**CITY OF NAPOLEON  
BUILDING CONSTRUCTION PERMIT**

ENGINEERING DEPARTMENT  
INTEROFFICE COMMUNICATION

To: Mr. Roy Dorsey From: Tom Terranova  
Building Permit No.: 118-73 Location: Lot #6 Riviera Heights  
Subject: Meeting at Job site today with Mr. Jiff Jones

Lot 8

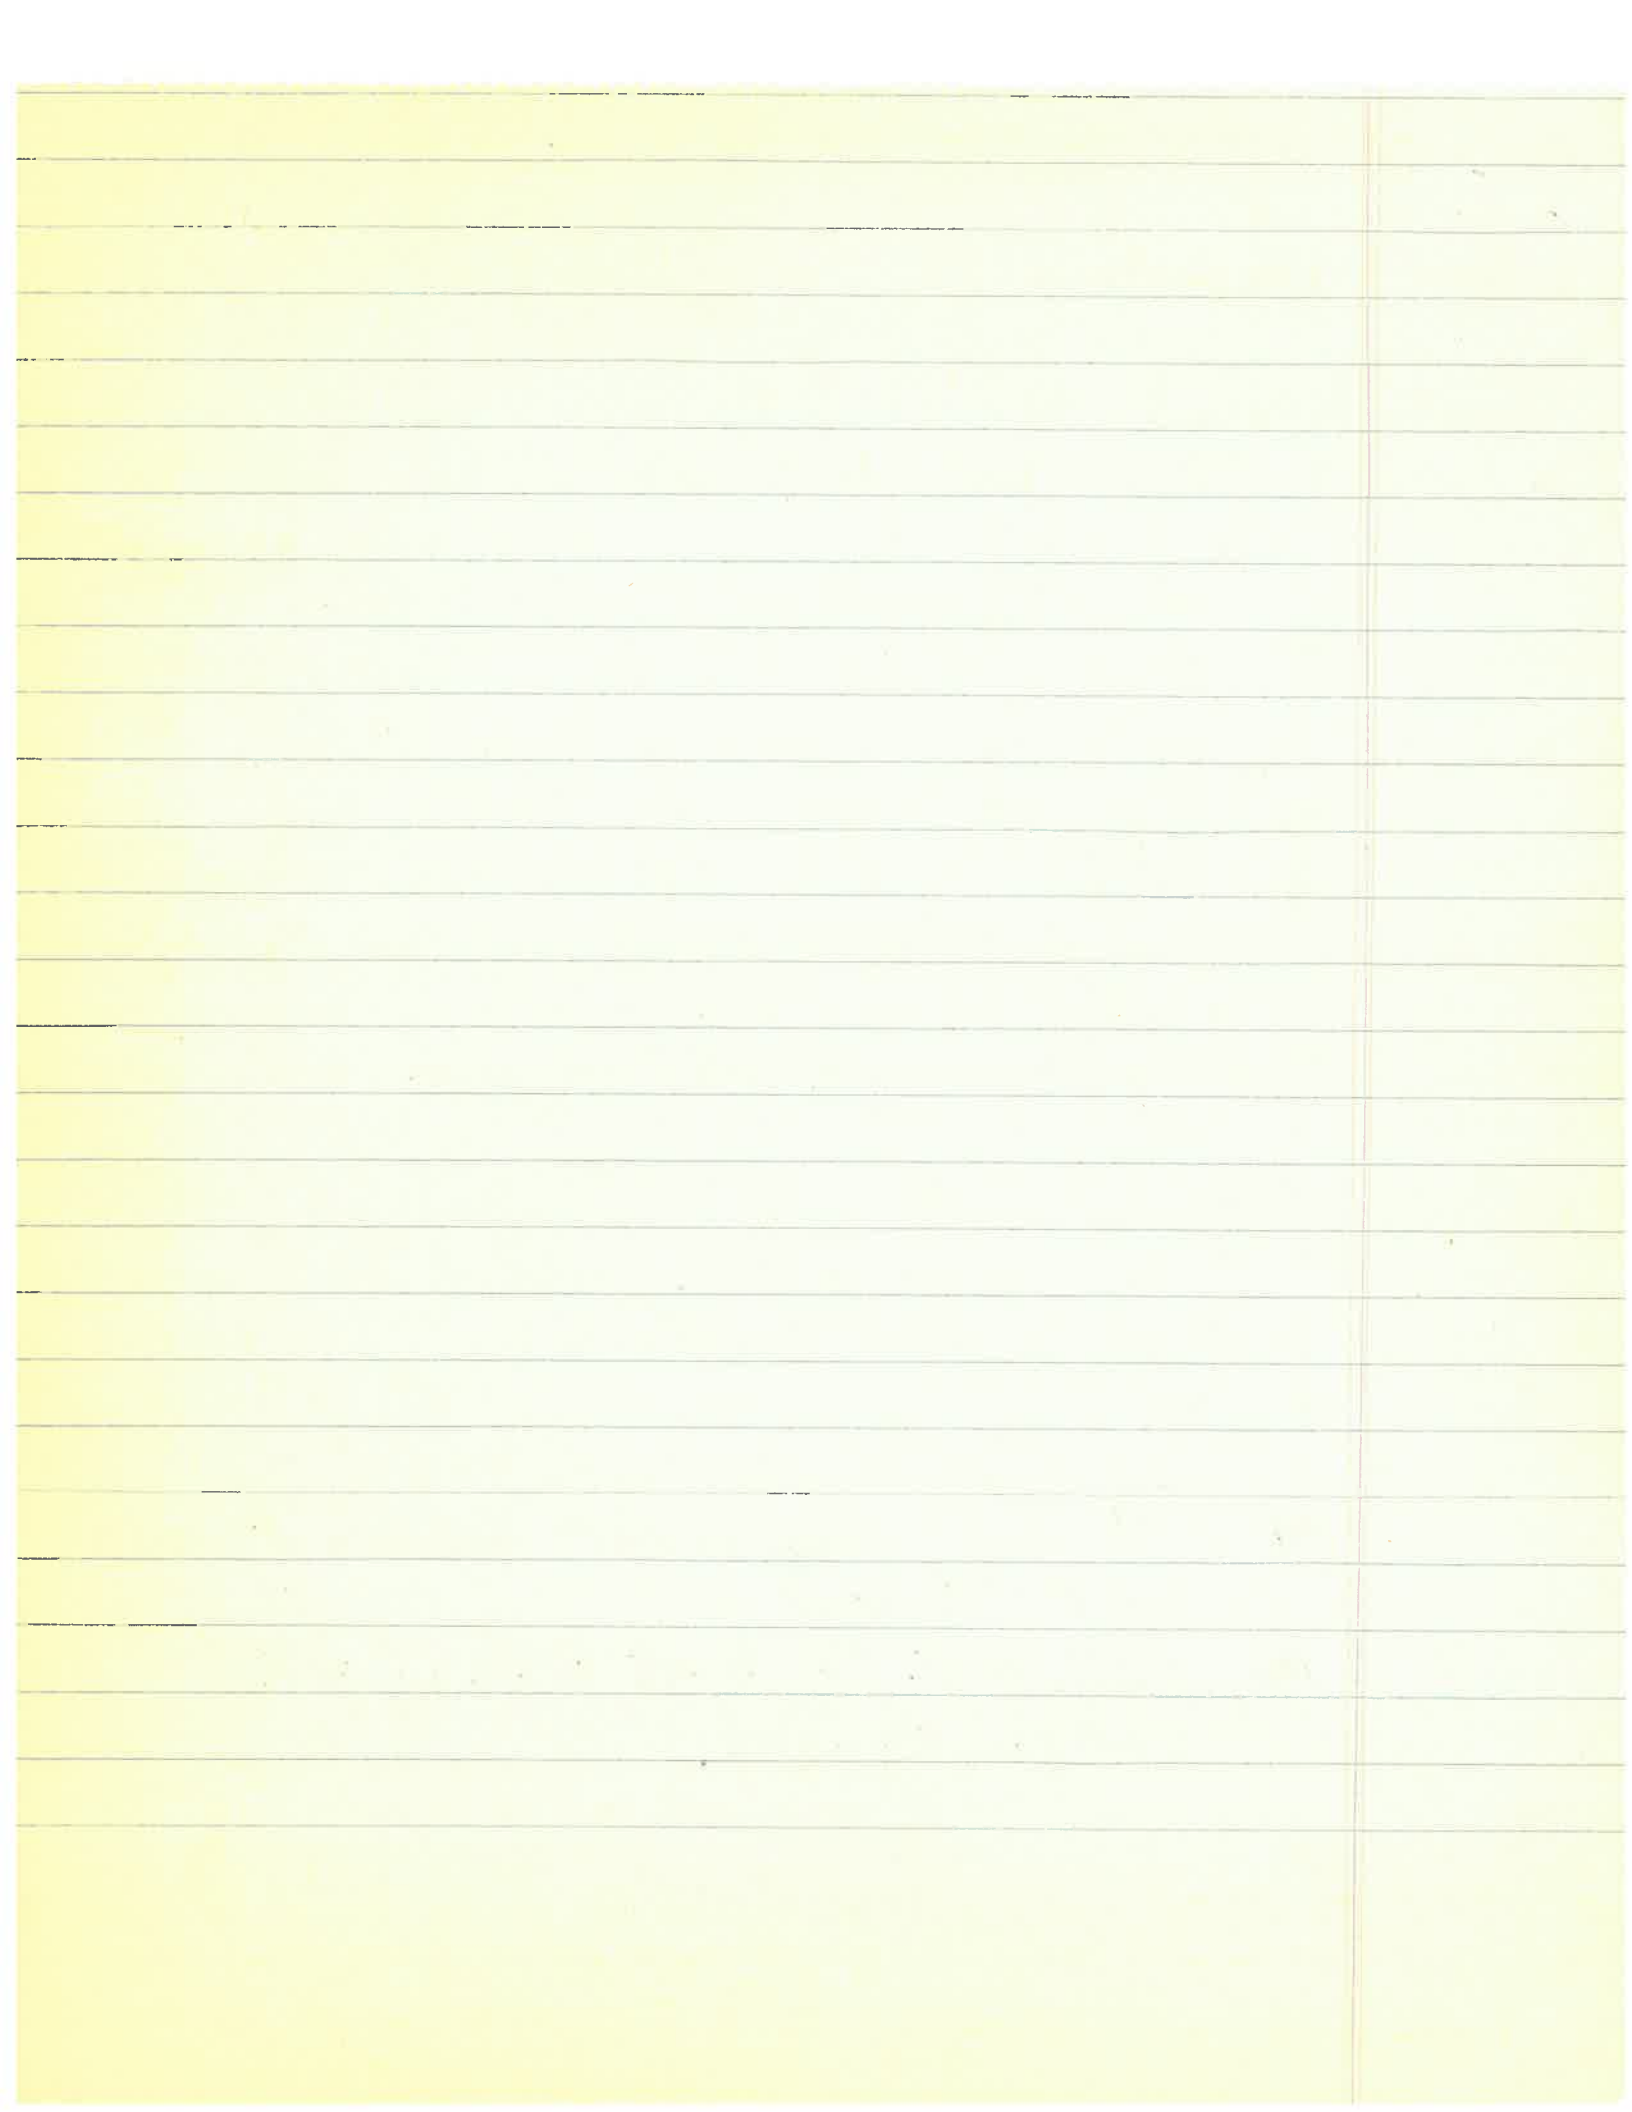
1. Only double 2x12 header over garage door ext.
2. Violation on min. distance of splice on top plates, example ext. garage wall. Gen. Conditions
3. ~~Single top plate on bearing partition on wall to right going down into lower level.~~ Corrected 8/29/74 P.W.P.
4. ~~Lower level improperly installed door headers joining into utility Rm & bath Rm.~~ Corrected 8/29/74 P.W.P.
5. 1/2" pipe on waste line for washing machine 2" required.
7. ~~Header directly above stairwell no support, carrying 4 roof truss 2x10 on center.~~ Corrected 9/12/74 P.W.P.
8. ~~Crawl space vents missing~~ corrected 9/12/74 P.W.P.
